To: T10 Technical Committee
From: Rob Elliott, HP (elliott@hp.com)
Date: 9 March 2007
Subject: 07-119r0 SAS-2 Far-end loopback phy test function

Suggested changes to SAS-2

Figure 1 — Far-end analog and far-end retimed loopback phy test modes

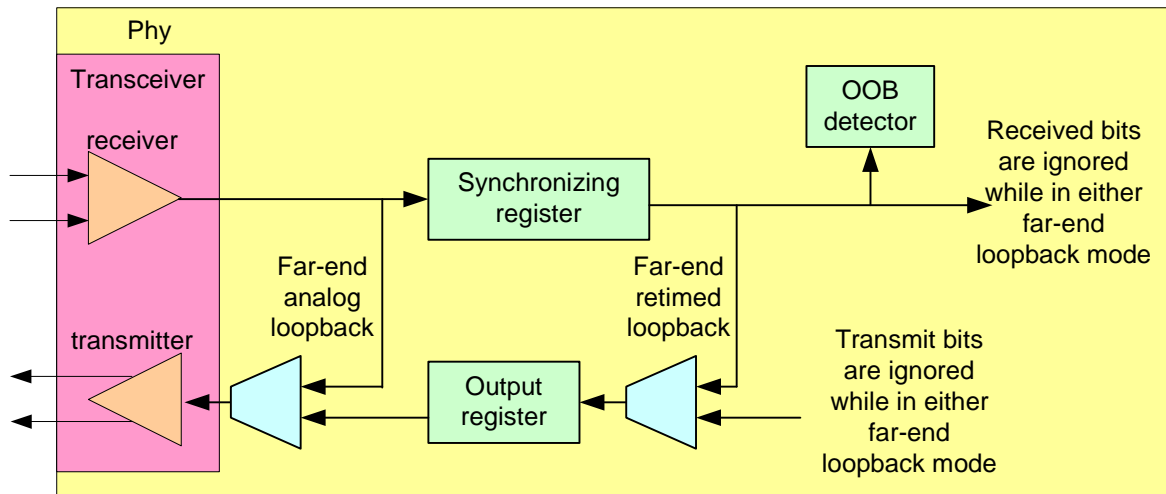
[In the far-end analog phy test mode, the phy shall retransmit the analog signal that it receives \(e.g., after an equalizer but before the clock recovery circuitry\).](#)

In the far-end retimed phy test mode, the phy shall retransmit the signal that it receives, after performing clock recovery and synchronizing the received signal to its transmit clock. The phy shall maintain dword synchronization. The phy may delete deletable primitives that it receives, and shall transmit a deletable primitive whenever it underflows (i.e., whenever the transmitter is ready to transmit a dword but the receiver has not provided another dword to transmit). The phy may transmit dwords with a different disparity that it receives them.

While in a far-end loopback phy test mode, the phy shall operate its OOB signal detector to detect COMINIT.

The phy shall remain in a far-end loopback phy test mode until:

- a) the phy test function is stopped via another phy;
- b) the phy receives a COMINIT;
- c) power off; or
- d) if it is in the far-end retimed phy test mode, the phy loses dword synchronization.

Figure 1 shows the far-end analog and far-end retimed loopback phy test modes.
